UNITED STATES PATENT AND TRADEMARK OFFICE

APPLICATION NO.	FILING DATE	FIRST NAMED INVENTOR	ATTORNEY DOCKET NO.	CONFIRMATION NO.
10/615,133	07/08/2003	Mary Morabito O'Neill	02W234	8119

Office Action Summary

DETAILED ACTION

Fig. 4

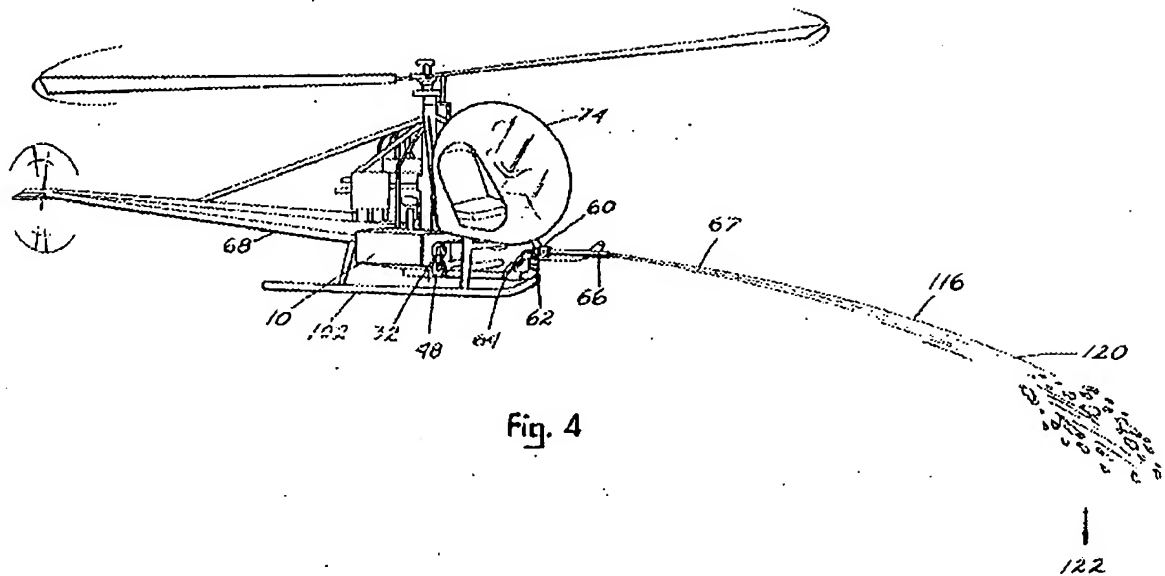
6. Claims 1, 2, 4, 6, 11, 14, 16, 22, 23, 24 and 26 are rejected under 35 USC 102(b) in view of US 4979571 issued to MacDonald. MacDonald discloses a method for obscuring an aircraft from infrared detection. Specifically, MacDonald discloses a foam producing apparatus for fighting fires comprising a helicopter as shown in Fig. 4 for transporting a pilot and fire retardant. A viewer at reference number 122 with infrared capabilities can see the heat given off by the engines of the helicopter. A mixture of CO₂ and water is used to put out fires (col. 6, ll. 41-66) at 122. A viewer at viewing location 122 would have its view of the engine heat (or exhaust plume) obscured by the flow of fire retardant. The obscurant is generated on the aircraft as shown at col. 6, ll. 41-66+. The method is capable of obscuring an auxiliary unit of the helicopter as well as the main engines. There is no disclosure of flares or infrared systems on the helicopter. The retardant is ejected from the front of the helicopter.

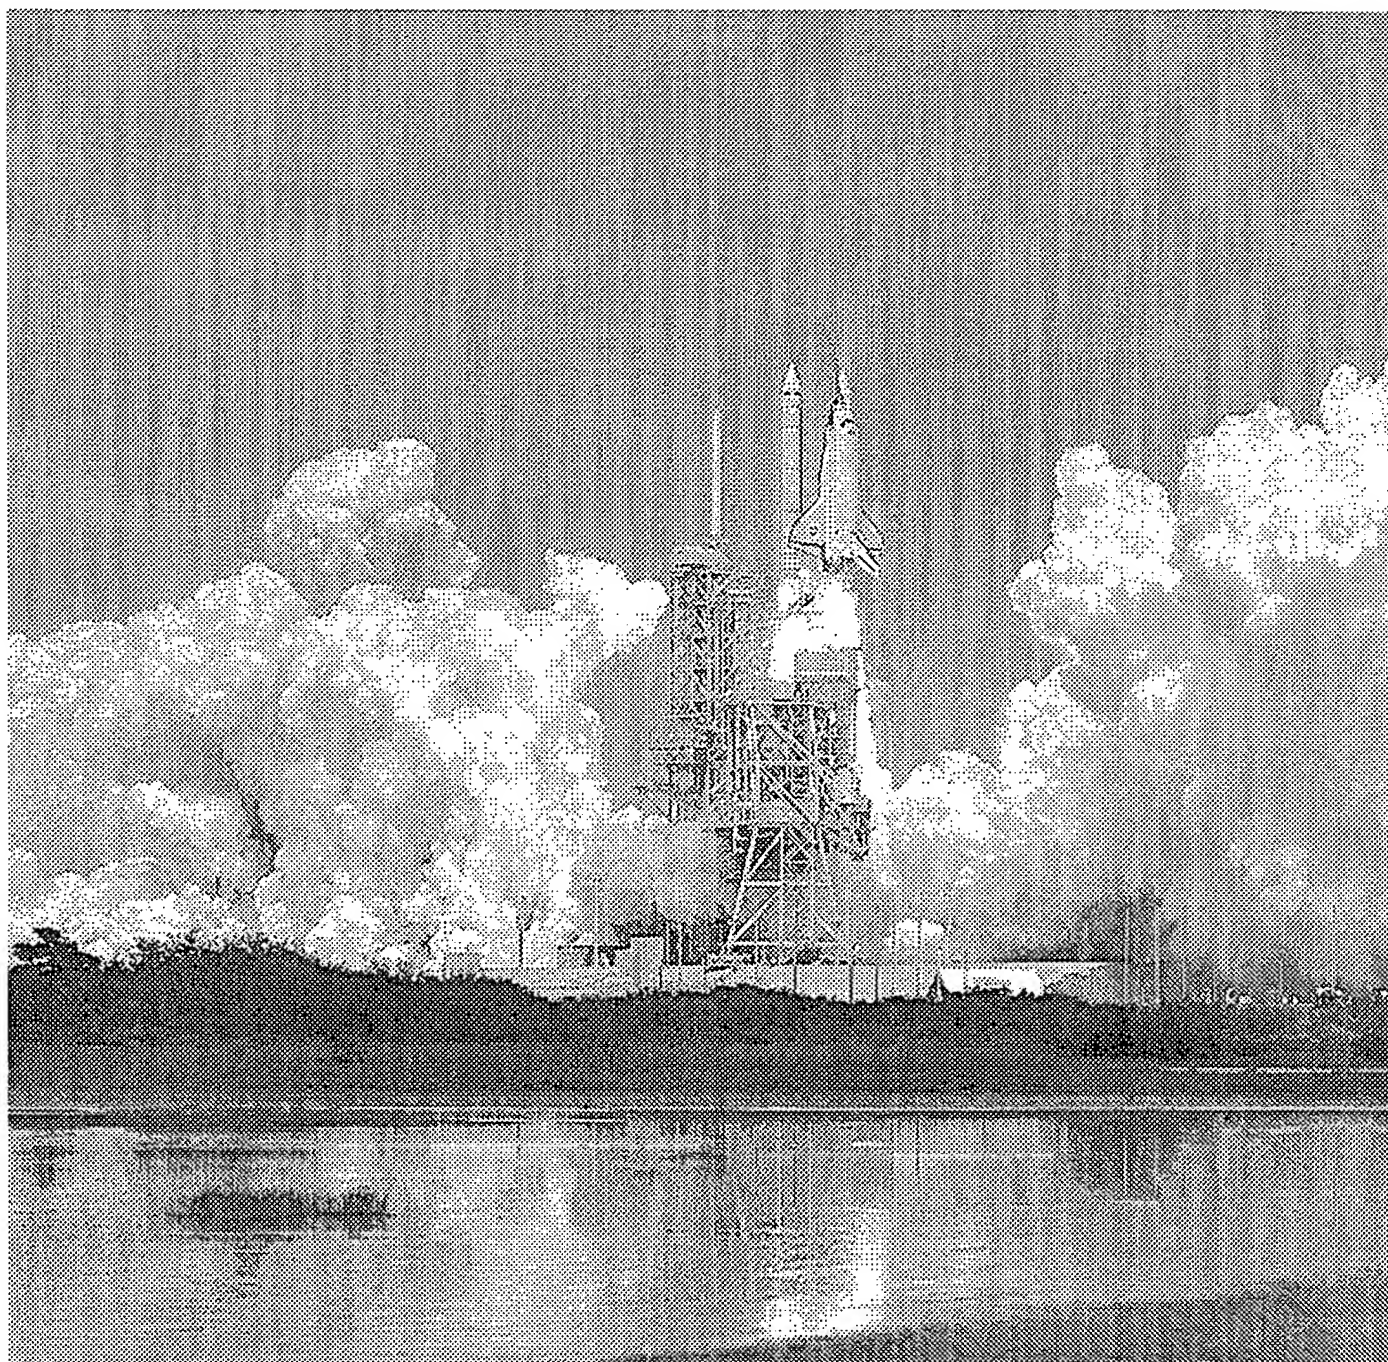
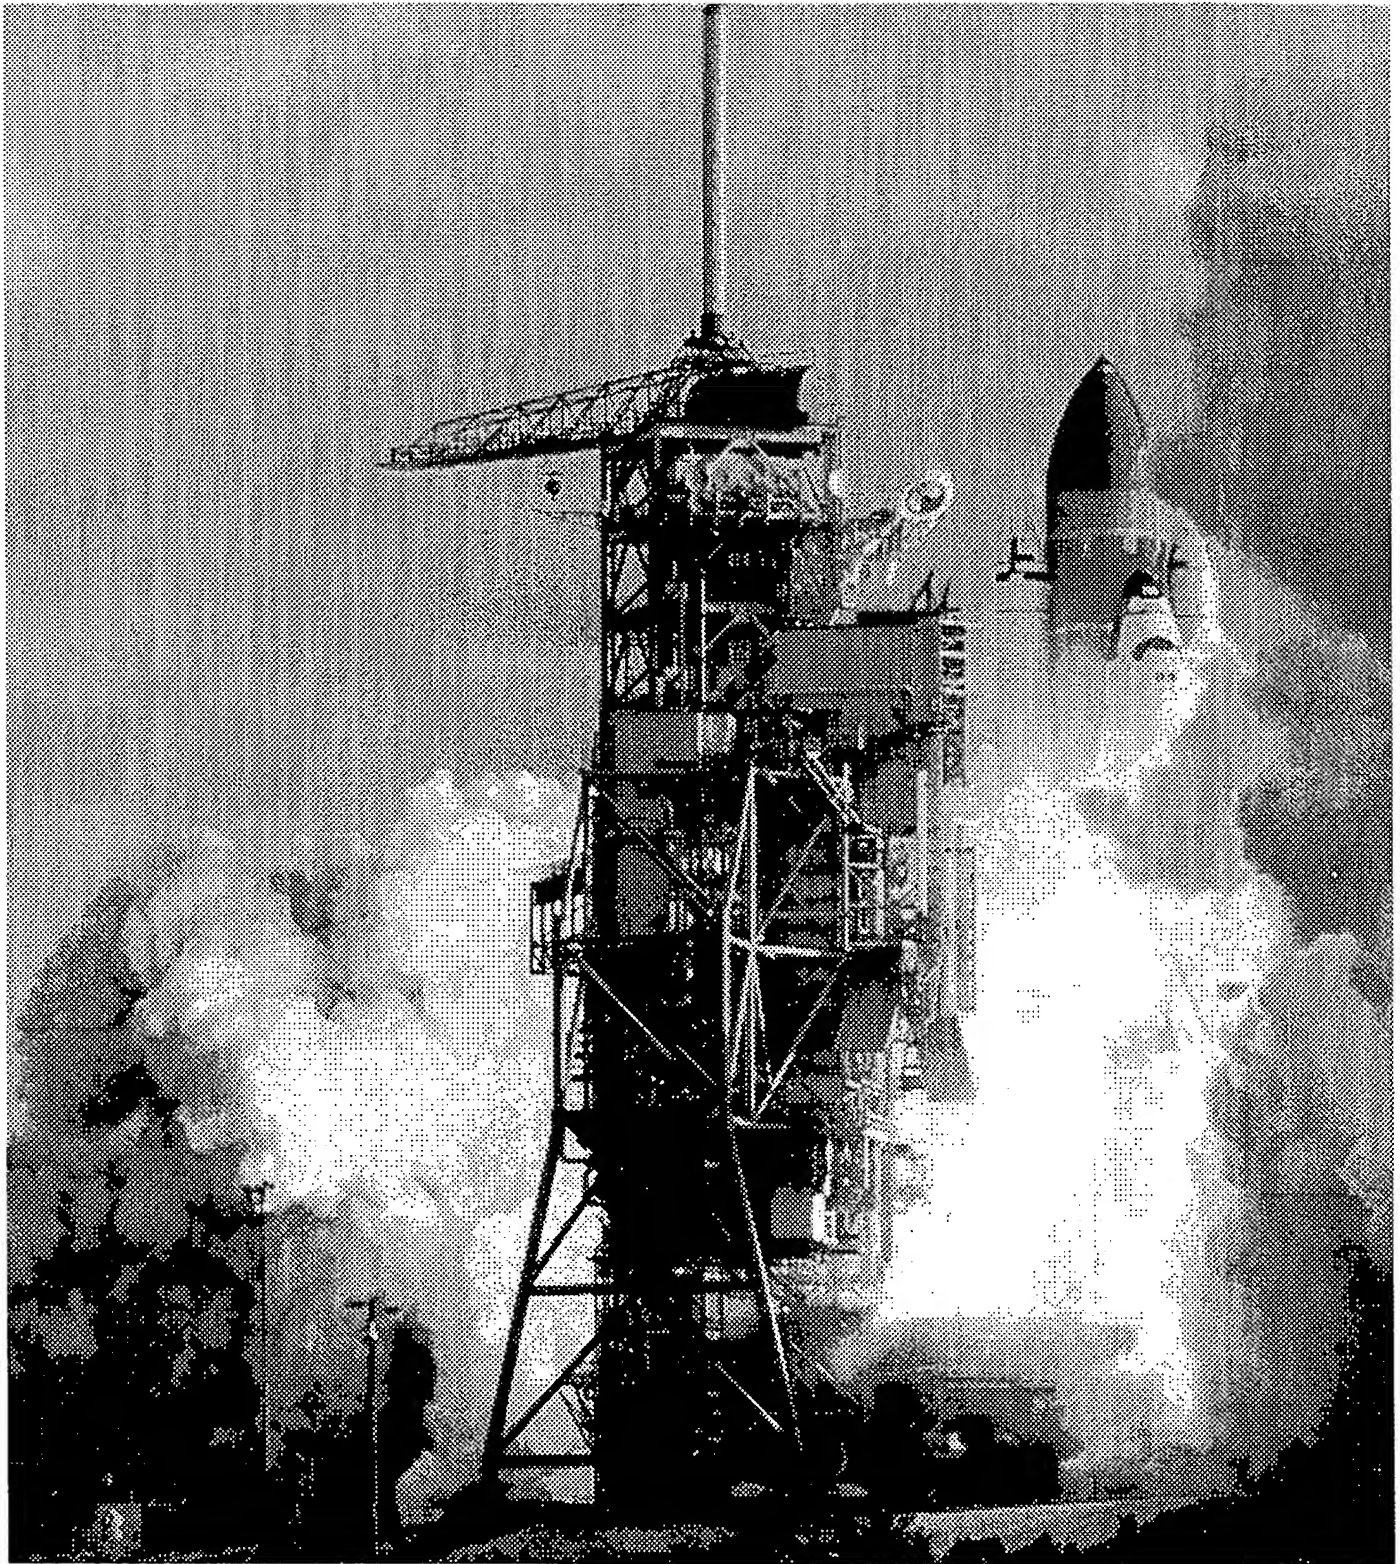
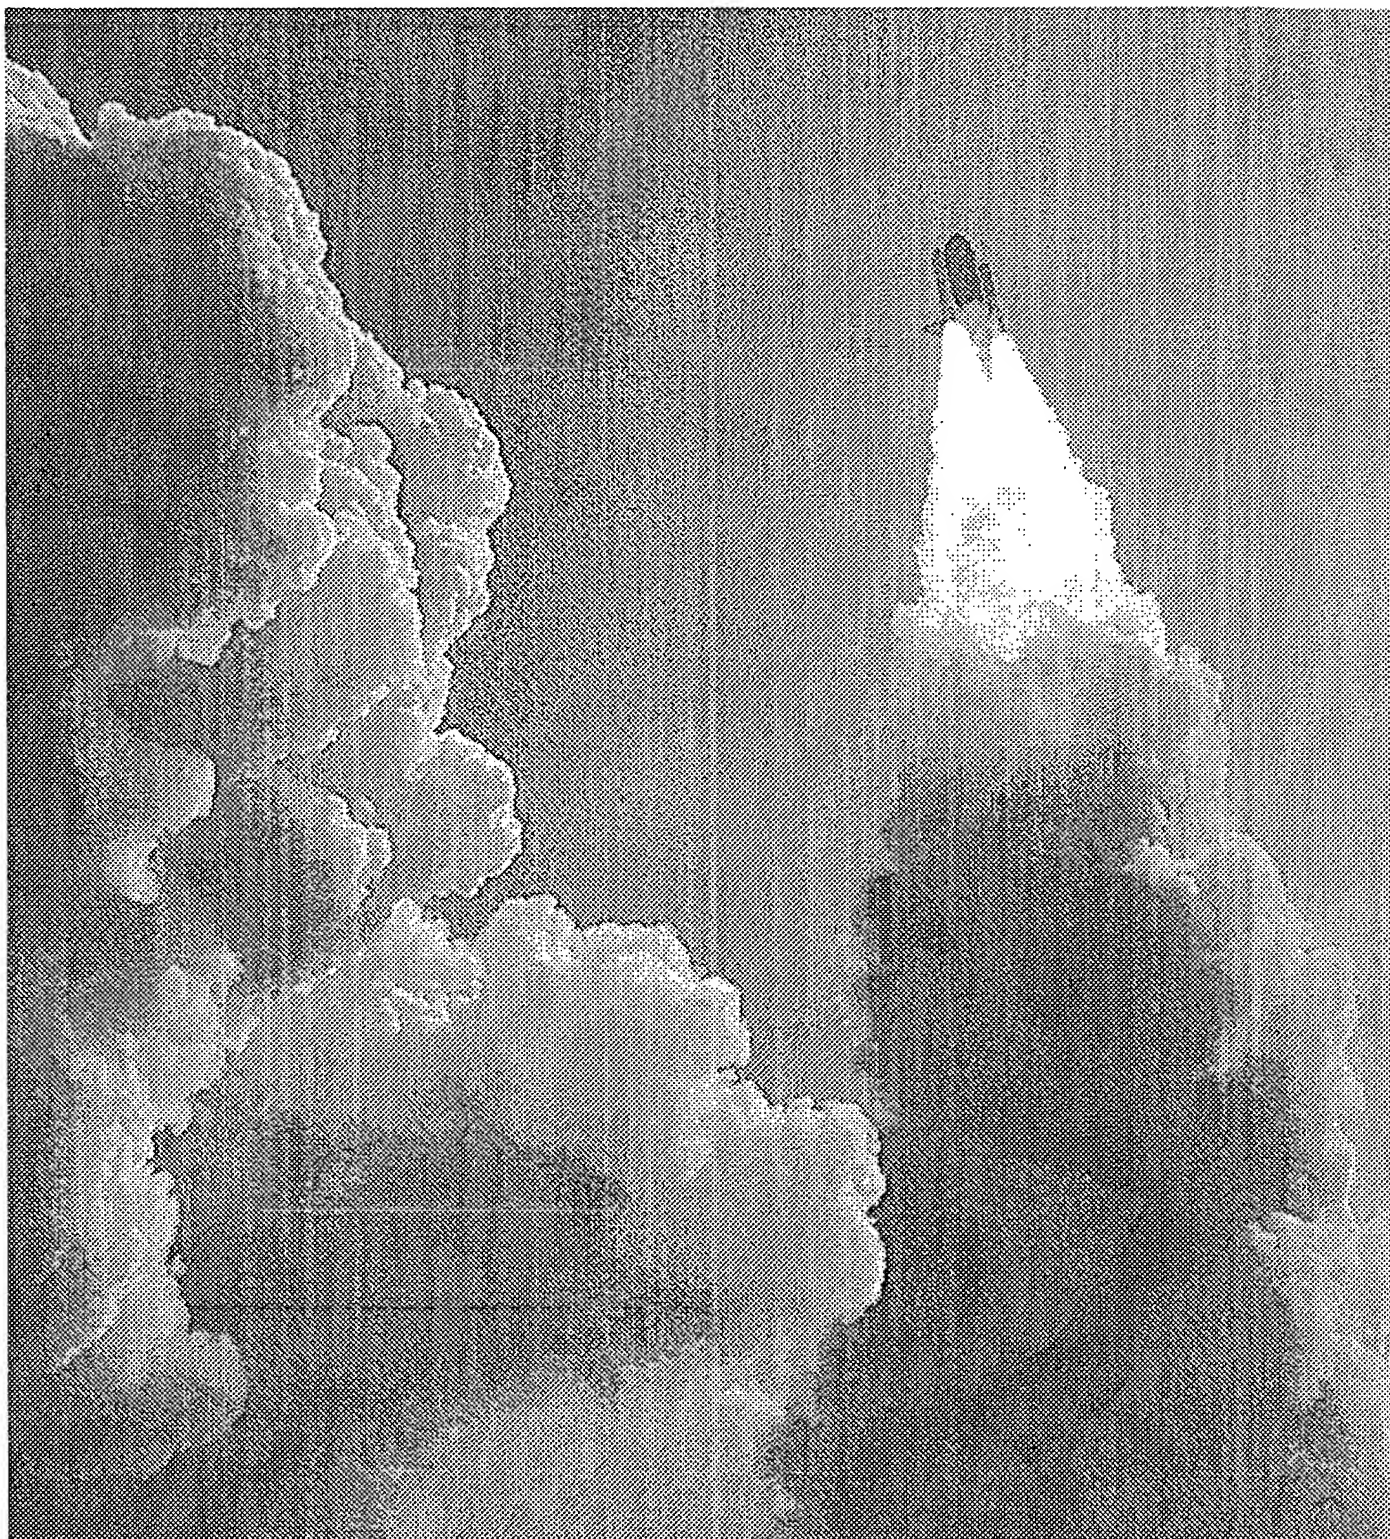
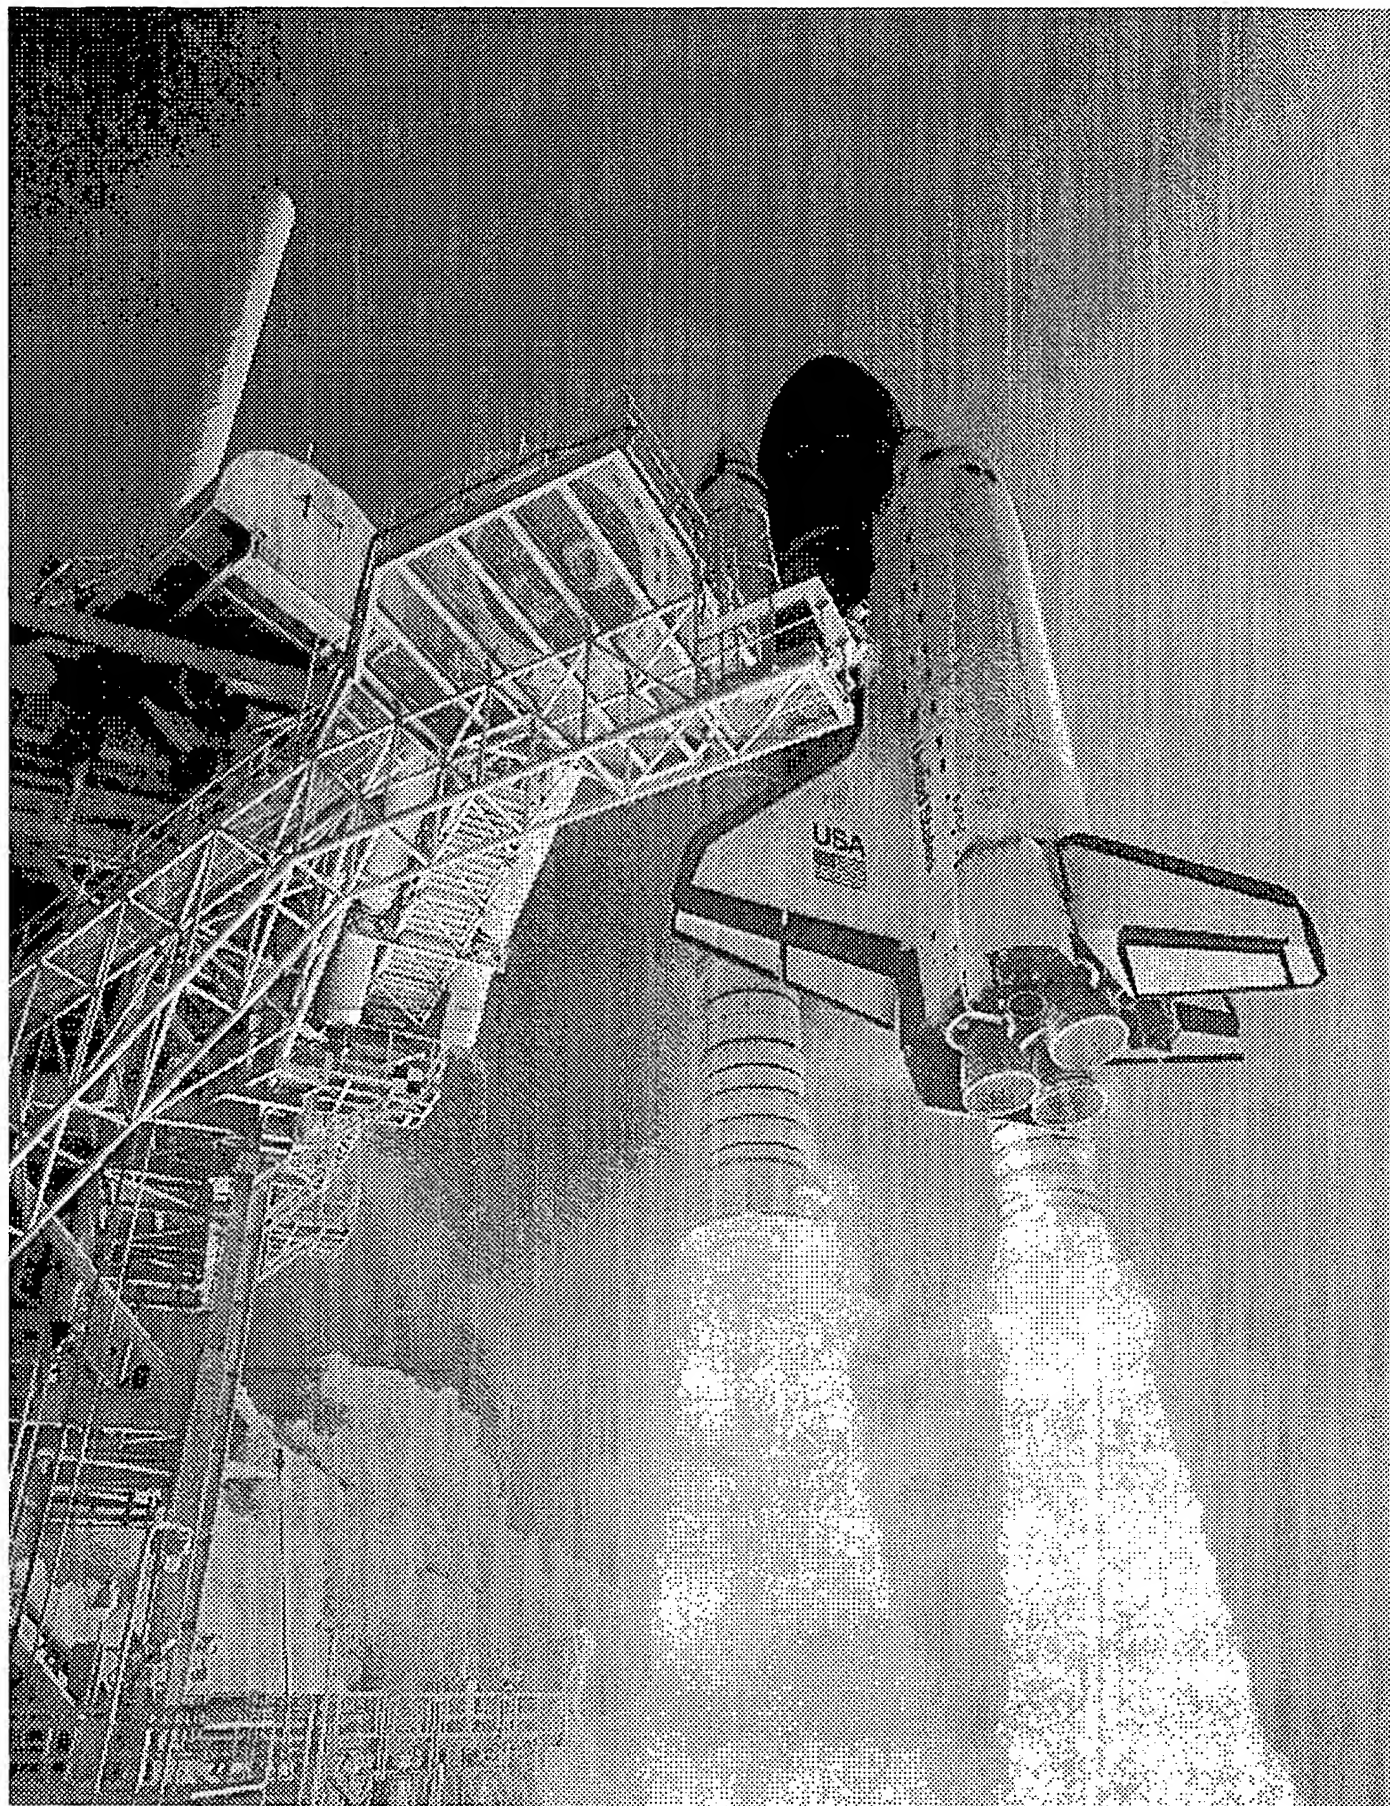
hydrogen, liquid oxygen and solid propellant (See any one of "Space shuttle main engine biography", "Solid Rocket Boosters", "How Space Shuttles Work" and "Space shuttle main engine"). At T minus 0 seconds the SRBs engines ignite the "source" of obscurant comprising solid propellant. As shown in the photos below, the shuttle is riding on a plume having a temperature greater than 150 degrees Celsius and is followed by great clouds of exhaust material, said exhaust inherently including traces of carbon dioxide and water vapor having a temperature less than that of the plume. As shown below, a viewer directly below or to the side of the shuttle during launch would have its view (infrared or otherwise) obscured by the clouds of obscuring agent.

25. With respect to claim 24, the obscuring agent is ejected to the sides and rear of the shuttle.
